Additional repairs resulting from the field inspection on 03/24/2014.

FRAMING PLAN - SUSPENSION SPANS 1 OF 6
BRIDGE NO. LUC - 2 - 1862
STATE ROUTE 2 OVER MAUMEE RIVER

LUC-2-18-62
PID No. 80551

REPAIR TYPE 201A: Top Flange Angle Repair with modified top flange splice

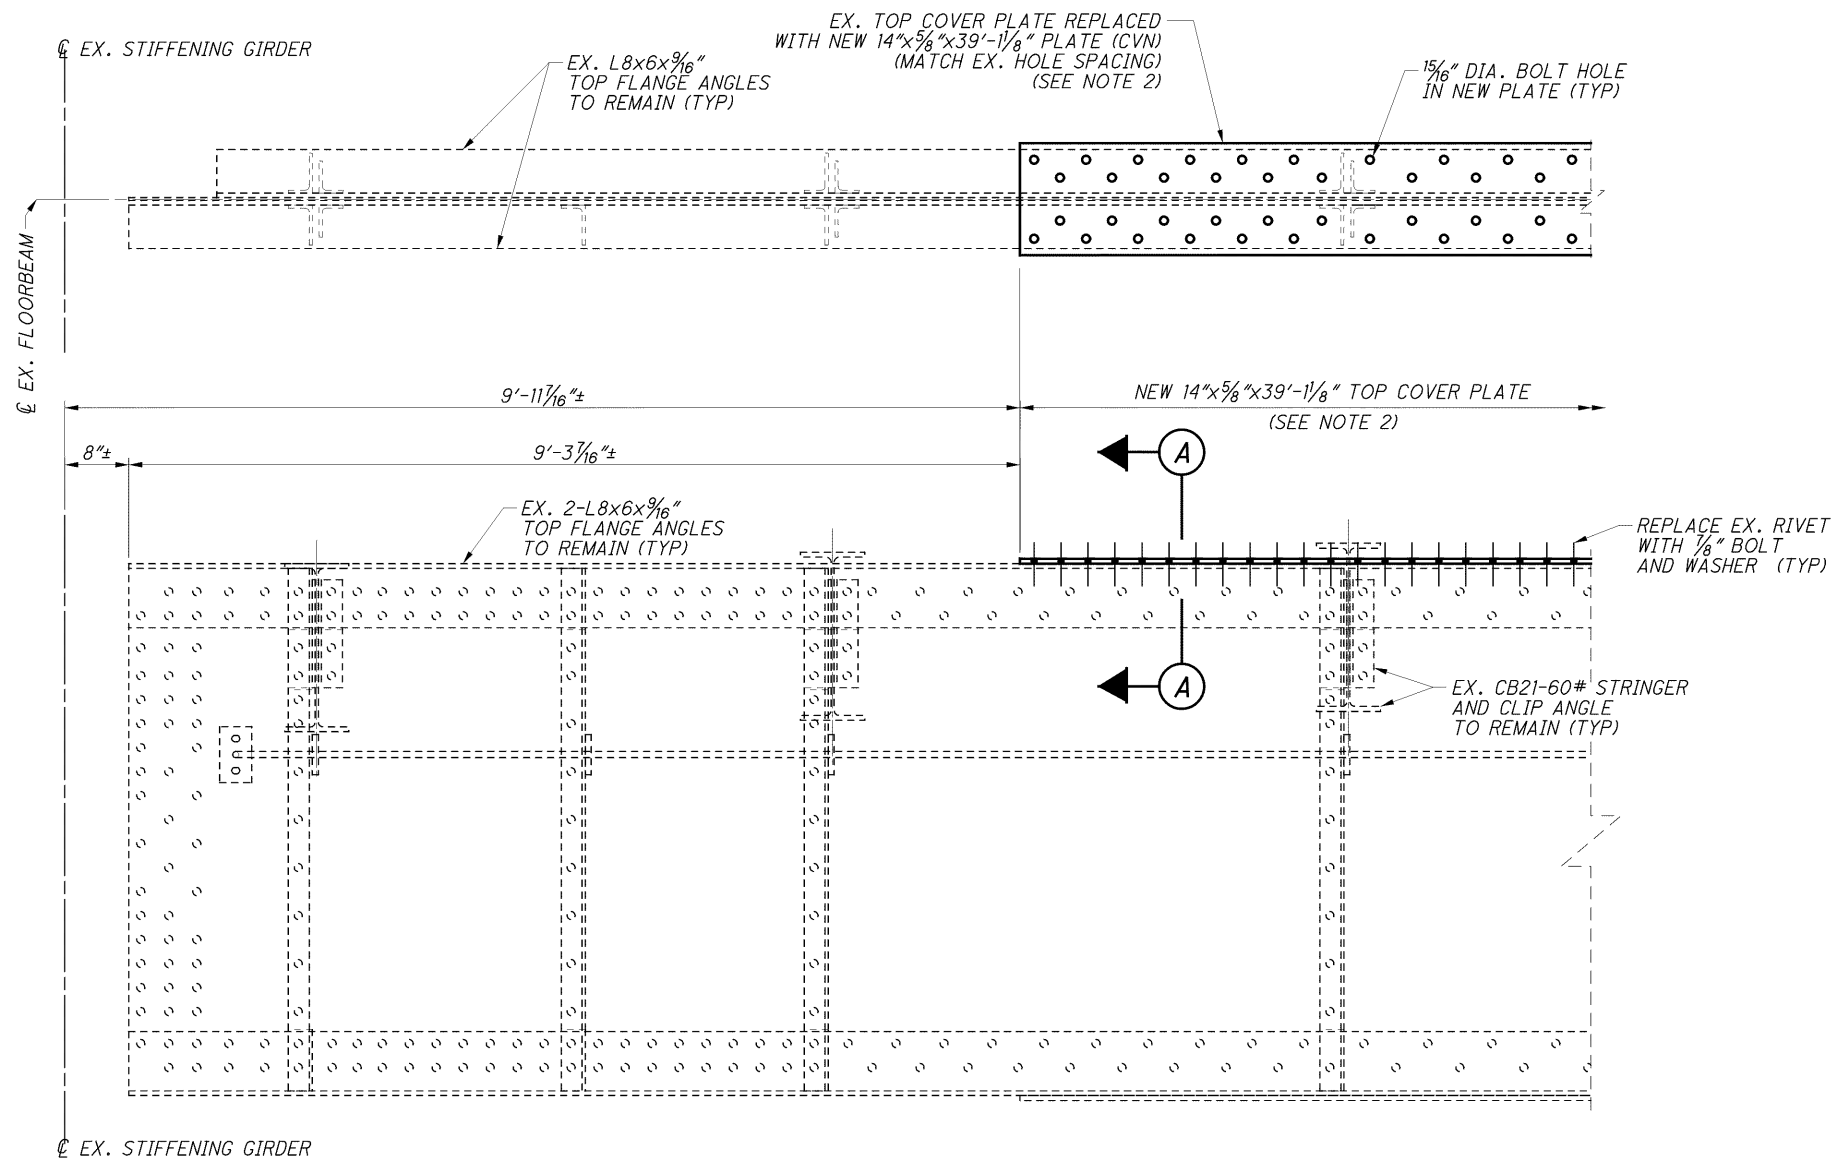
NOTE: THIS REPAIR ADDS A LONG TOP FLANGE ANGLE REPLACEMENT TO THE WORK ON FLOORBEAM 28. ALL OTHER PLANNED FLOORBEAM 28 WORK IS UNCHANGED.

Provide web and flange splice plates and connectivity as shown.

MODIFIED
REPAIR TYPE 203
 NOTE: FLOORBEAM END REPAIRS
 APPLY TO LEFT END ONLY.

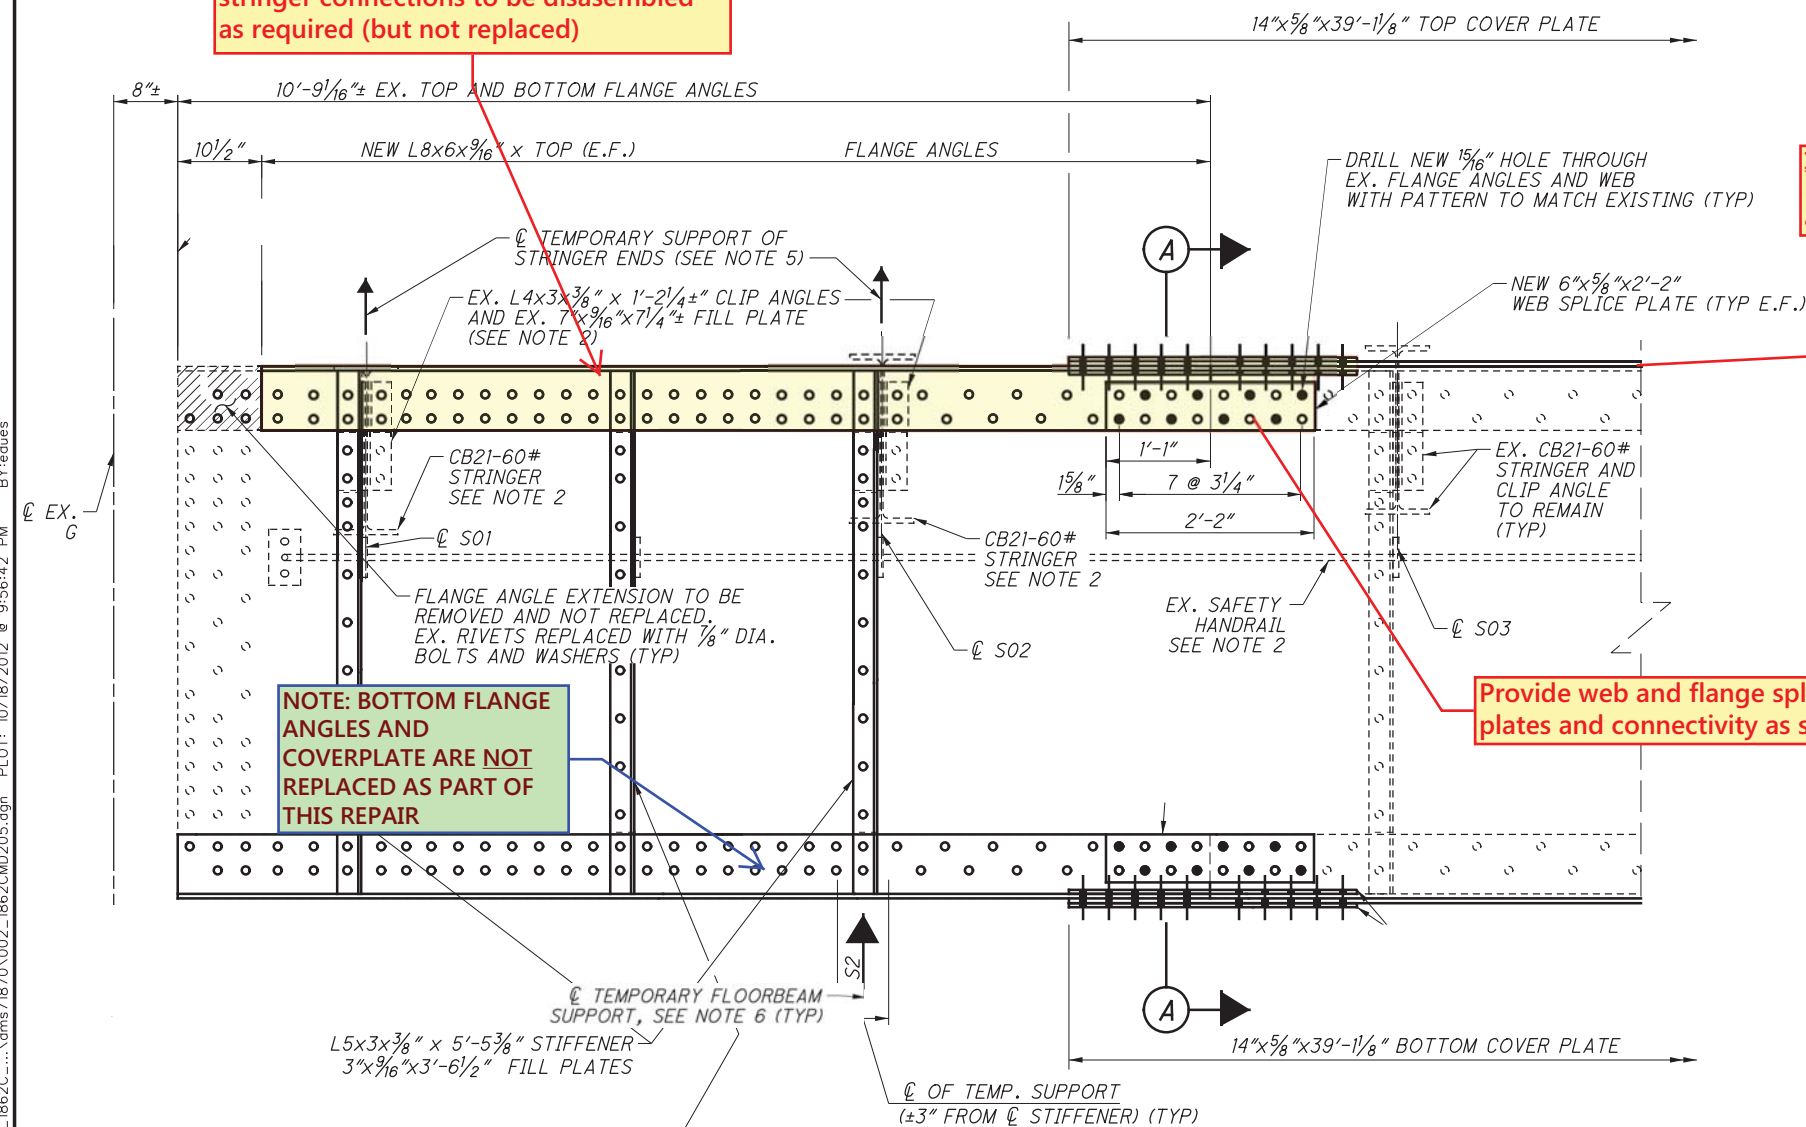
NOTE: THIS REPAIR IS COMPRISED OF A TOP FLANGE ANGLE BEING REPLACED FROM THE END OF A FLOORBEAM TO A POINT UNDER THE TOP FLANGE COVER PLATE. ALL OTHER PLANNED REPAIRS AT AFFECTED FLOORBEAMS (INCLUDING TOP FLANGE COVERPLATE, IF PREVIOUSLY PLANNED) SHALL STILL BE PERFORMED PER THE ORIGINAL CONTRACT DRAWINGS.

Replace top flange angles for the length shown. Existing floorbeam stiffeners and stringer connections to be disassembled as required (but not replaced)

IF APPLICABLE: Modify originally planned Repair Type 202 top flange coverplate to allow for top flange splice as shown.

Provide web and flange splice plates and connectivity as shown.

REPLACE EX. CRIMPED STIFFENER WITH
NEW L5x3x $\frac{3}{8}$ " x 5'-5 $\frac{3}{8}$ " STIFFENER
AND NEW 3"x $\frac{9}{16}$ "x4'-2" FILL PLATE
(REFER TO REPAIR TYPE 205
FOR ADDITIONAL DETAILS)

Unexpected Stiffener Detail

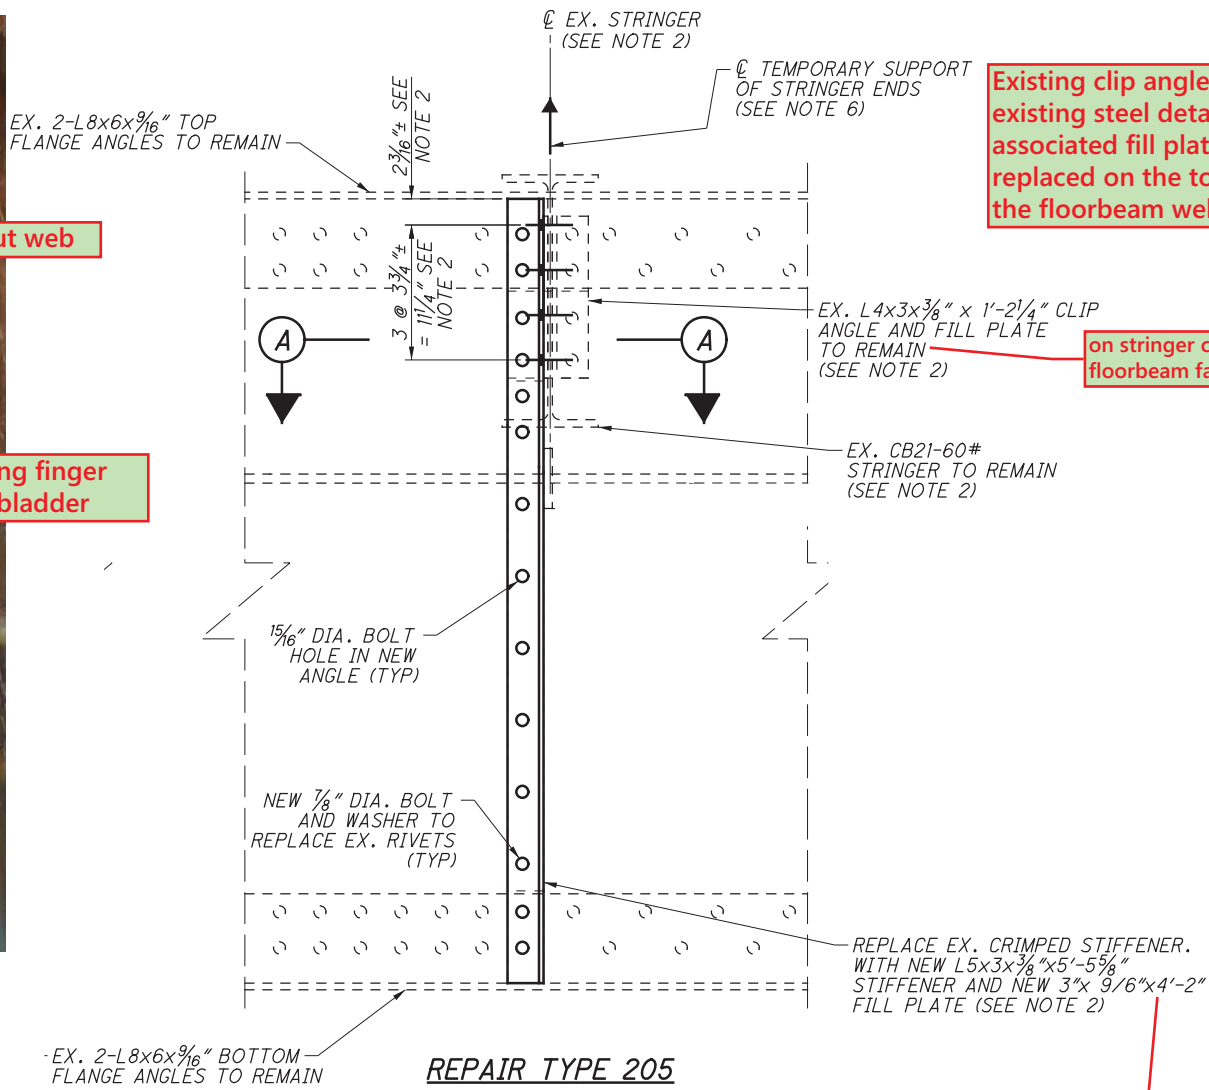
On the tower strut face, there is no stringer but it appears that the clip angles and fill plates were added. If present, these should not be replaced. Only a stiffener should be present on the tower strut face.

The existing floorbeam stiffeners adjacent to the tower strut should be replaced with stiffeners and fill plates as part of the suspension span Stage 6 deck and joint replacement. This repair is necessary because the existing condition and modified stiffener arrangement will not work with the proposed modular joint support details. Existing clip angles on the stringer face of the floorbeams may be reused. Clip angles on the tower strut face of the floorbeams shall not be replaced.

REPAIR TYPE **215B-2**
(STRENGTHENING PLATE DETAIL)

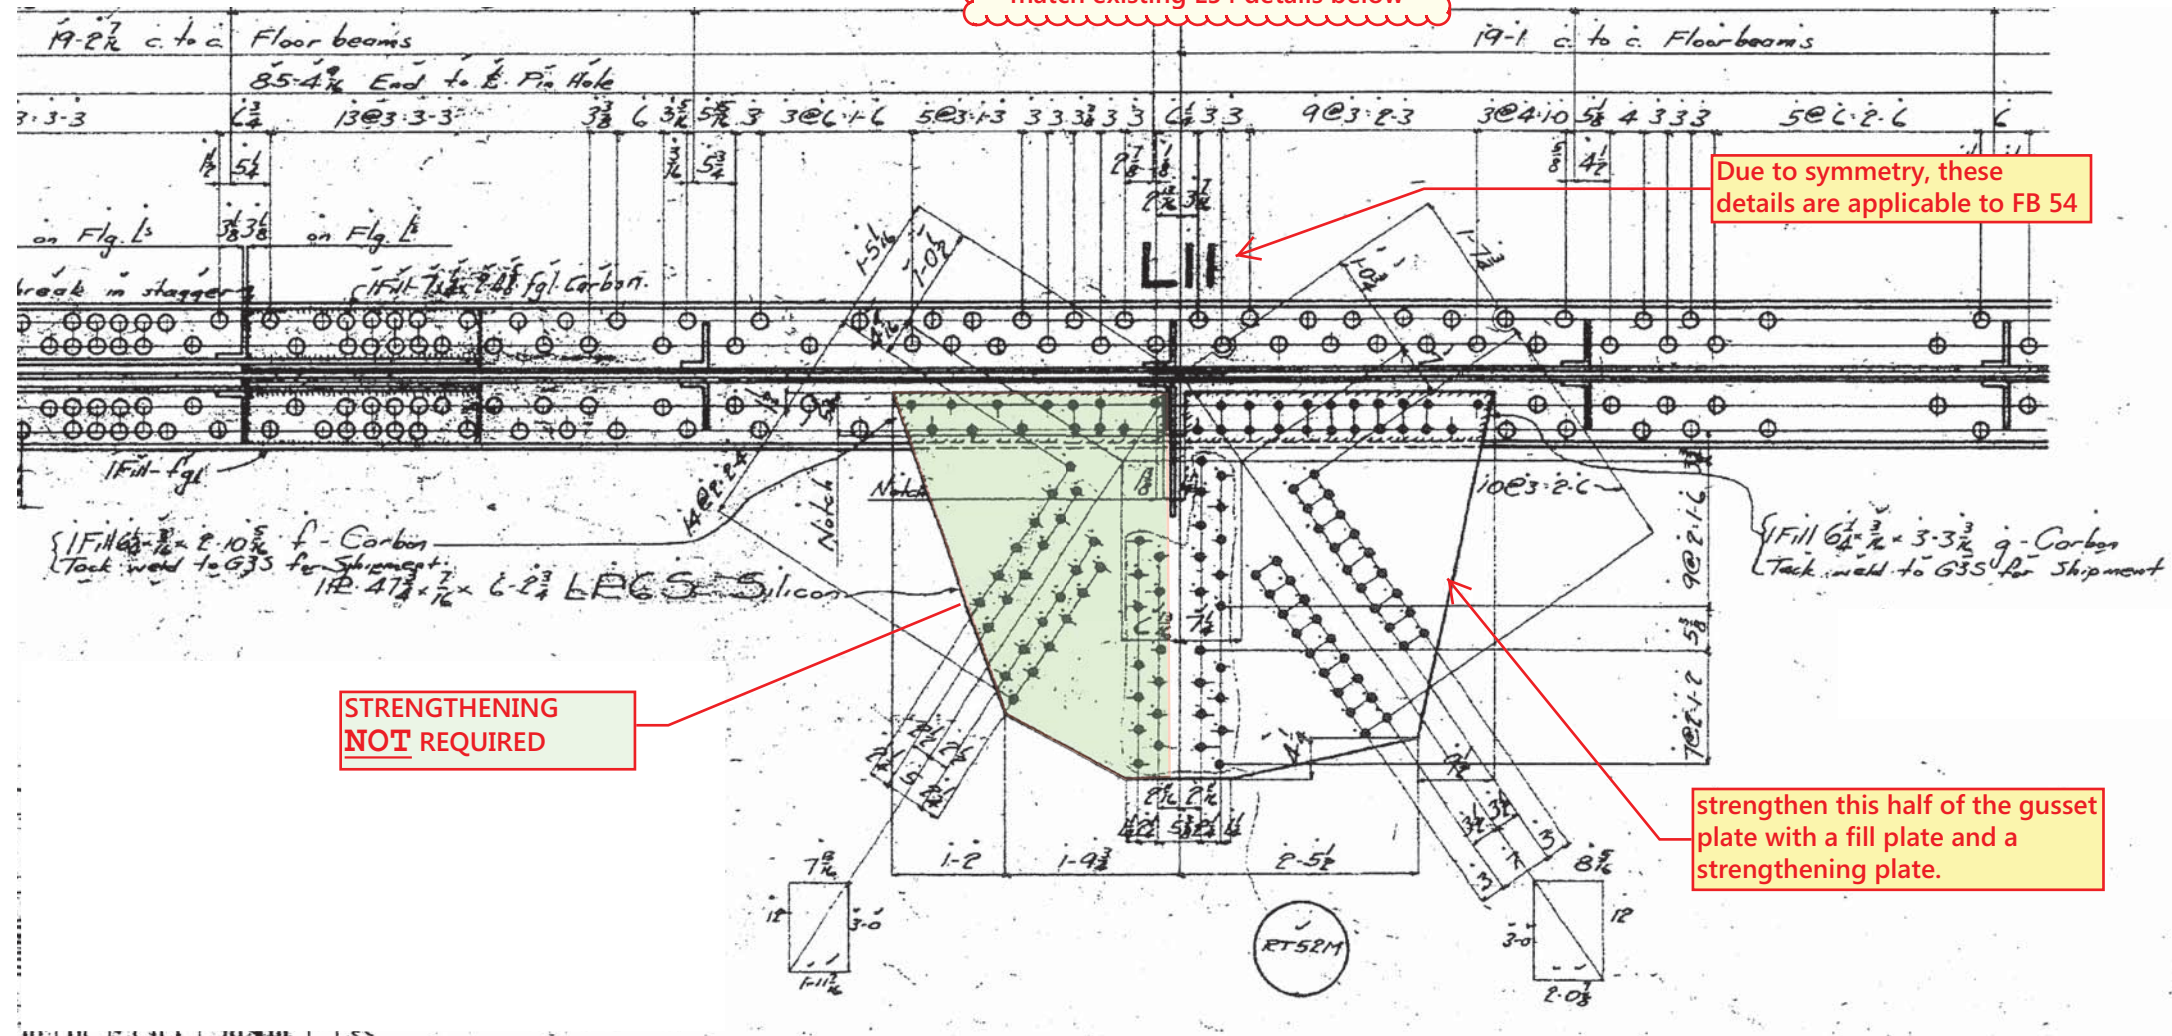
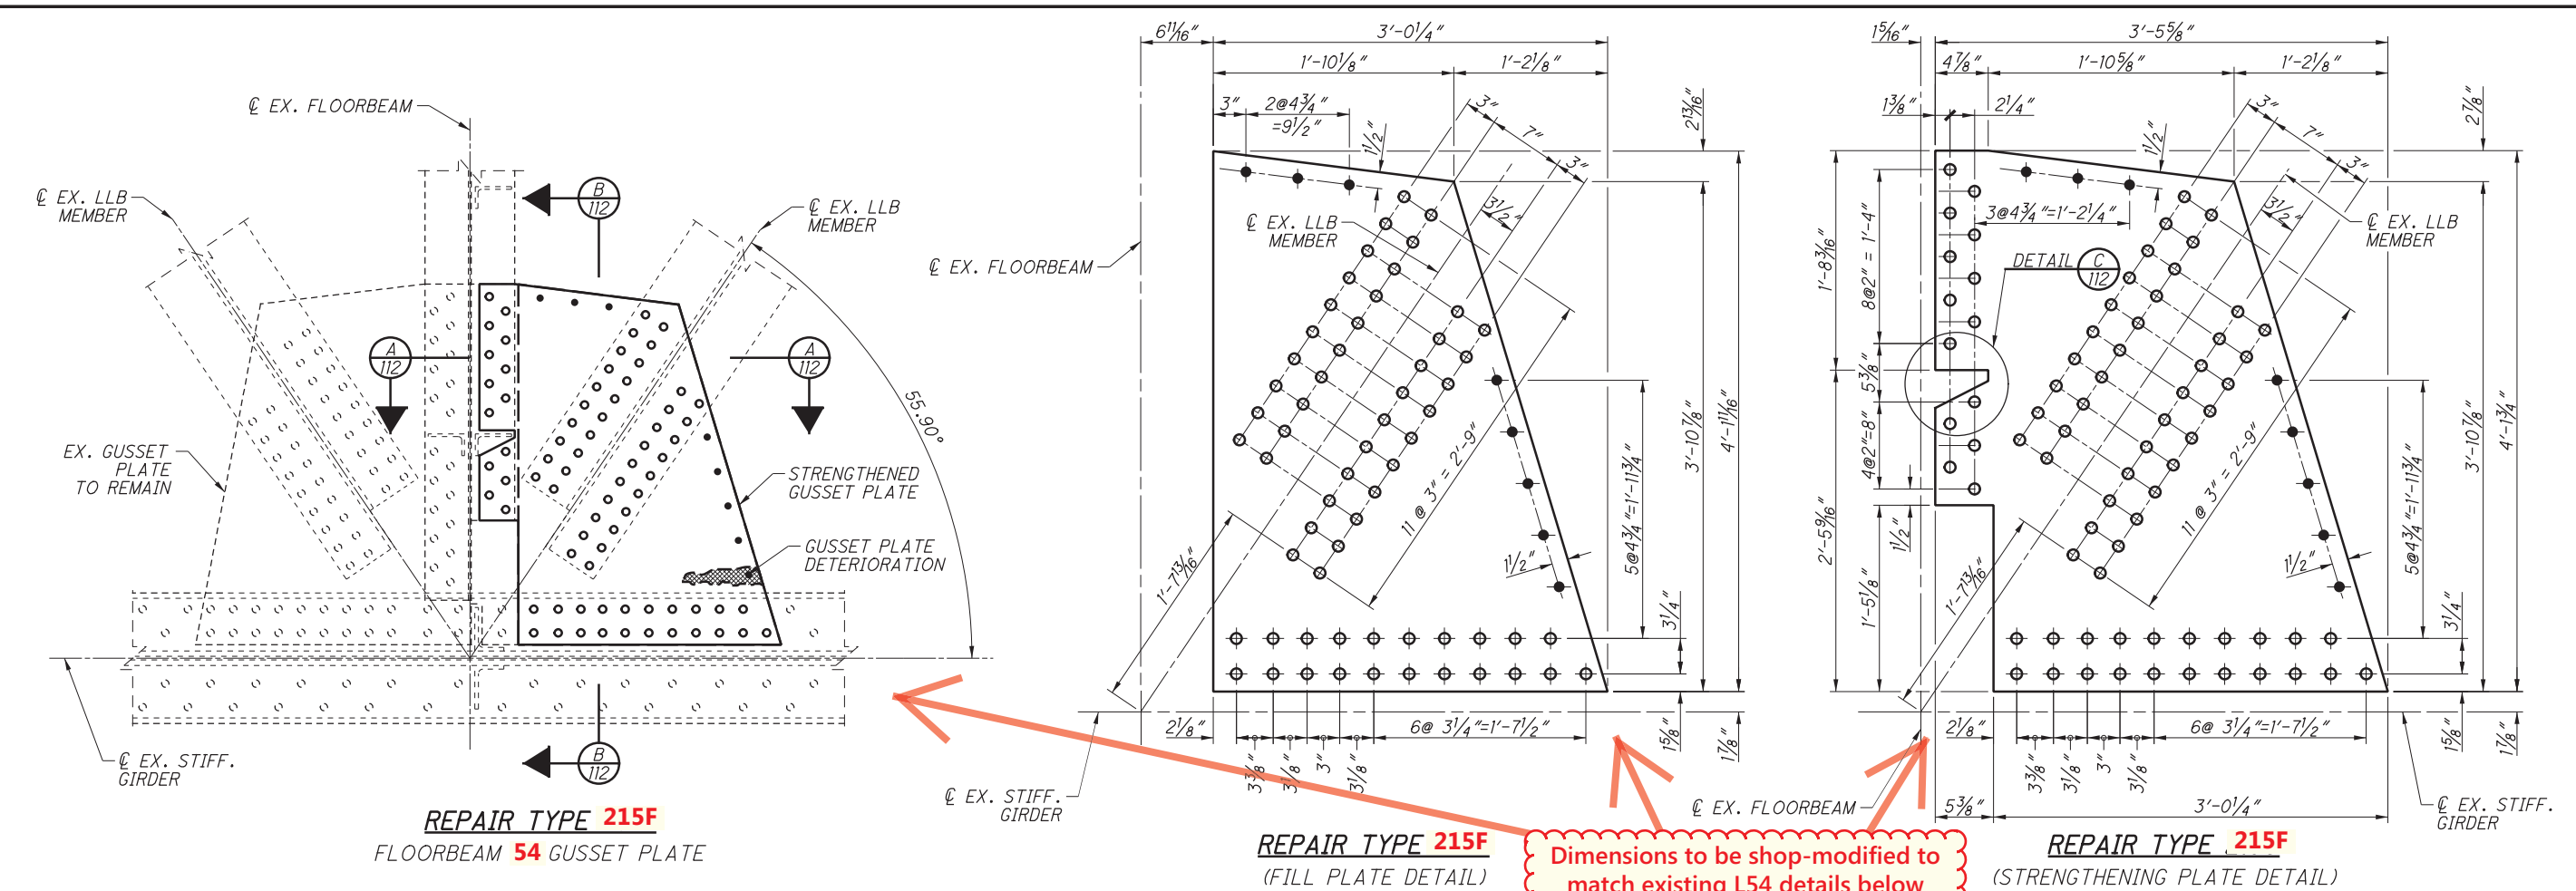
The shape of the lower lateral gusset plate is hexagonal (Repair Type 215). However, the details will differ from those already shown in the contract plan. As such, the existing gusset plate details from the original 1930 steel details have been provided to aid in shop detailing of the additional repair type 215b-2 required at Floorbeam 20.

Dimensions to be shop-modified to match existing L16 details above.

215F NOTE:
The shape of the lower lateral gusset plate is hexagonal (Repair Type 215). However, the details will differ from those already shown in the contract plan. As such, the existing gusset plate details from the original 1930 steel details have been provided to aid in shop detailing of the additional repair type 215F required at Floorbeam 54
